**March 2018 Project Modifications Report  
– Loyalist Solar Project**

Loyalist Solar LP

**Date:** April 26, 2018

#### 2.1.1 *Modification – Removal of Proposed Noise Mitigations*

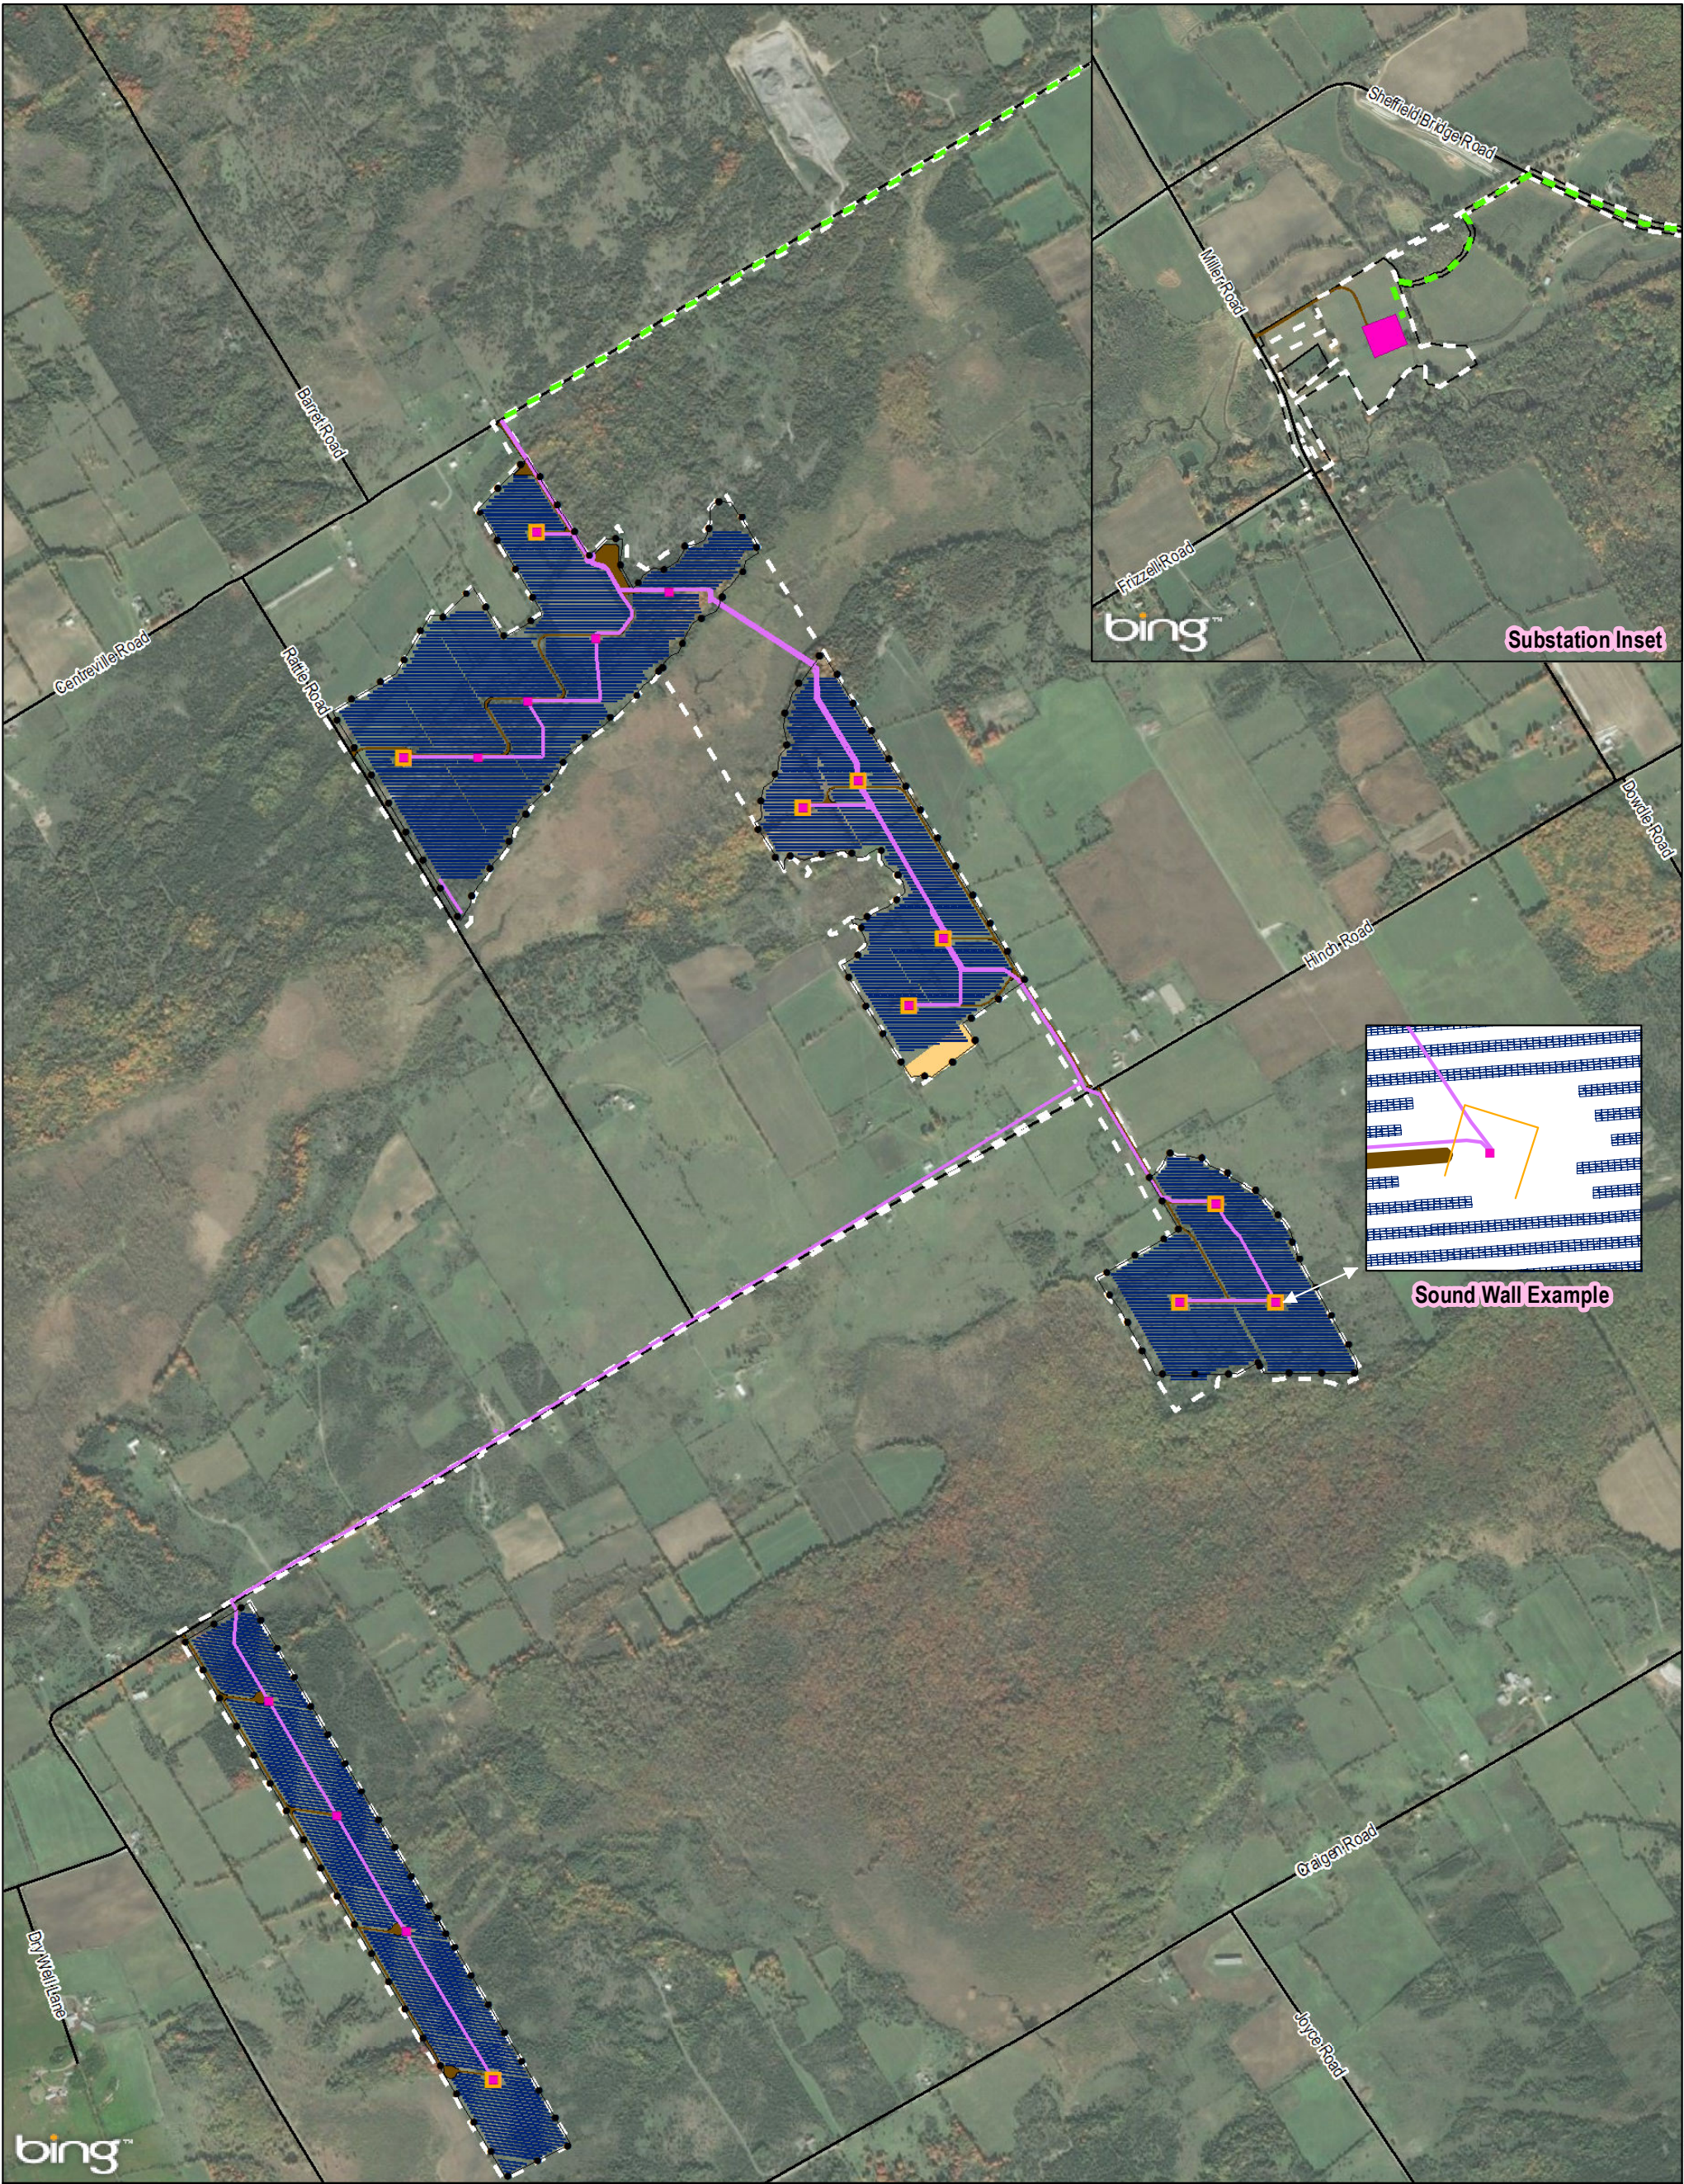
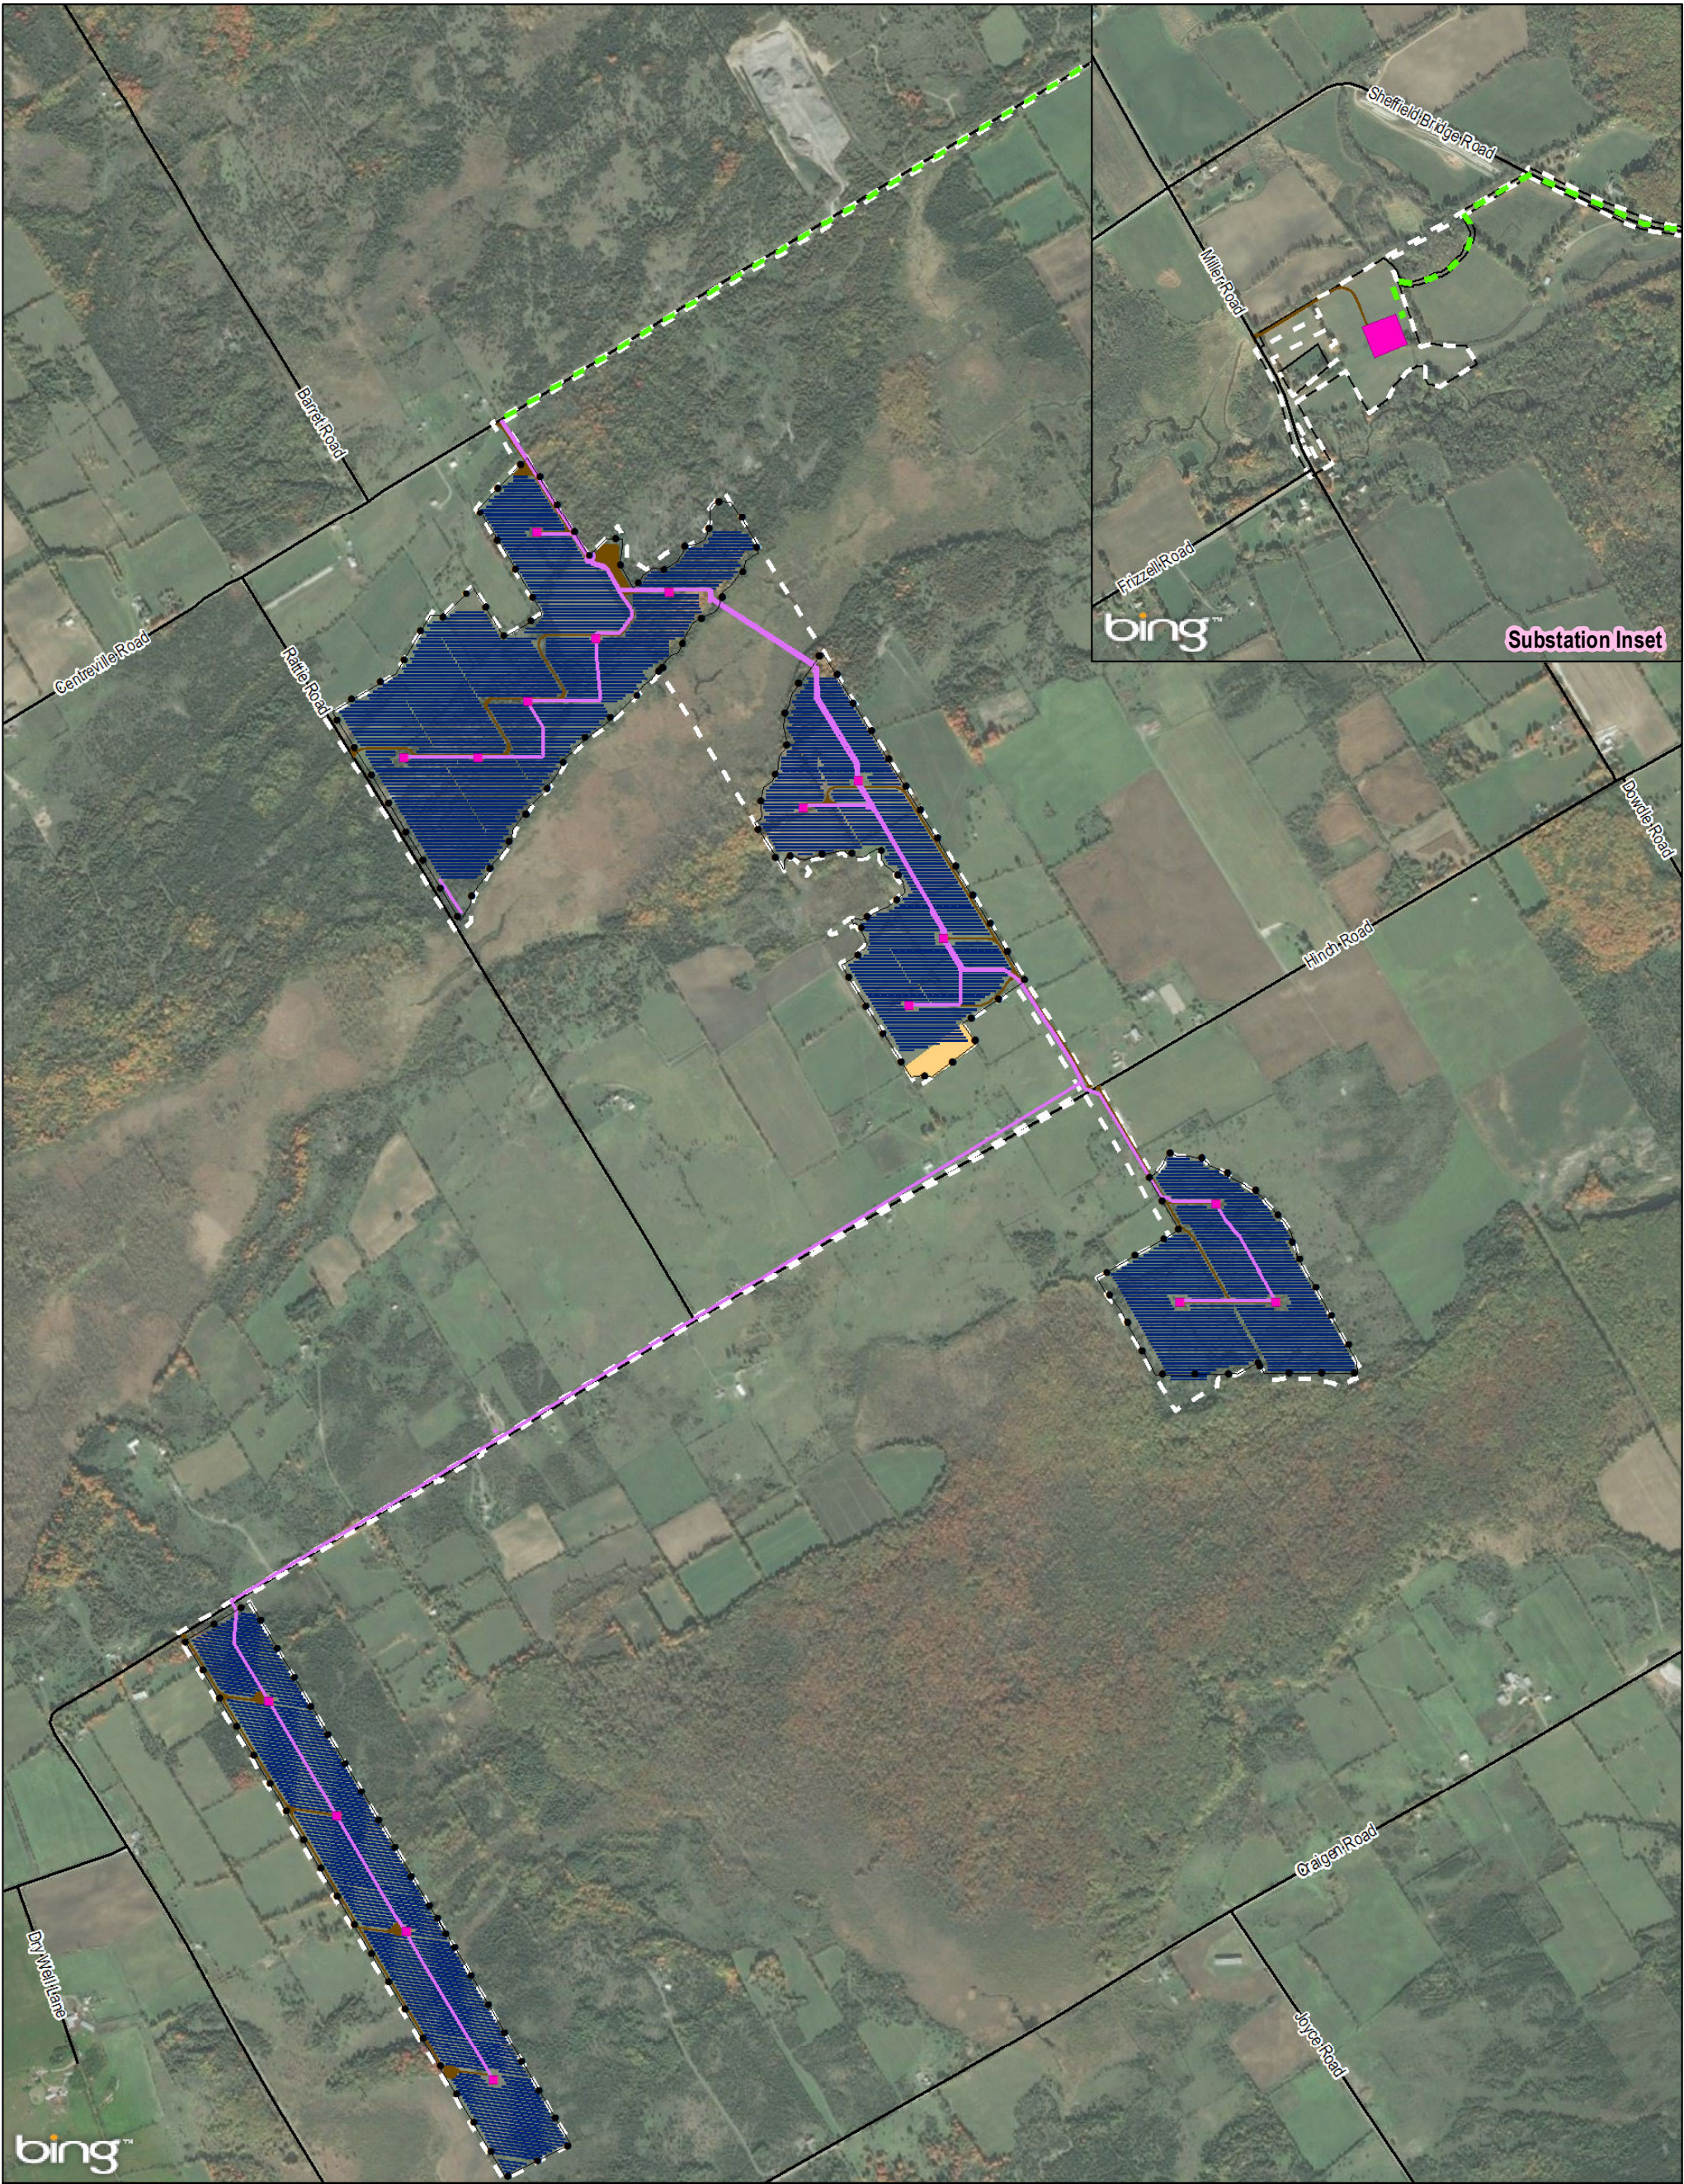
The Proponent is proposing modifications to the Project that involve the removal of noise mitigations from the inverters stations. Inverter stations house multiple components, including electrical inverters, inverter transformers and monitoring equipment. The operation of inverters during daylight hours produces noise which must not exceed allowable levels at receptors.

The original REA submission on February 7, 2017 did not include noise mitigations as these were determined not to be necessary to achieve compliance with noise regulations. As part of a pre-REA modification in December 2017 which involved a change to the site layout (refer to Project Modification Report (AECOM, December 2017), noise mitigations were added to the Project to in order to maintain minimal increases in noise at receptors as a result of the changes. In the approved REA, “U” shape and “L” shape noise barriers were proposed to be installed around noise sources (e.g., inverter clusters).

Following the receipt of the REA Approval, the Proponent determined that the planned noise mitigations were not required in order for the Project to maintain noise levels below the 40 dB limit as per the MOECC’s noise regulations for renewable energy projects. The removal of the barriers from the Project is anticipated to result in minor noise level increases at some receptors, but noise levels at all receptors are predicted to remain below the 40 dB limit. Therefore, no additional mitigation is required.

The location of this modification is presented in the Revised Site Plan located in **Appendix B**.

Loyalist Solar Project		
Proposed Layout-No Sound Walls		
March 2018	1:16,000	Datum: NAD83, Zone17 Source: LIO, BING
P#: 60543768	V#:	Figure 2
<b>AECOM</b>		
<div><div>0</div><div>275</div><div>550</div><div>1,100</div></div> <div>Meters</div>		
<p>This drawing has been prepared for the use of AECOM's client and may not be used, reproduced or relied upon by third parties, except as agreed by AECOM and its client, as required by law or for use by governmental reviewing agencies. AECOM accepts no responsibility, and denies any liability whatsoever, to any party that modifies this drawing without AECOM's express written consent.</p>
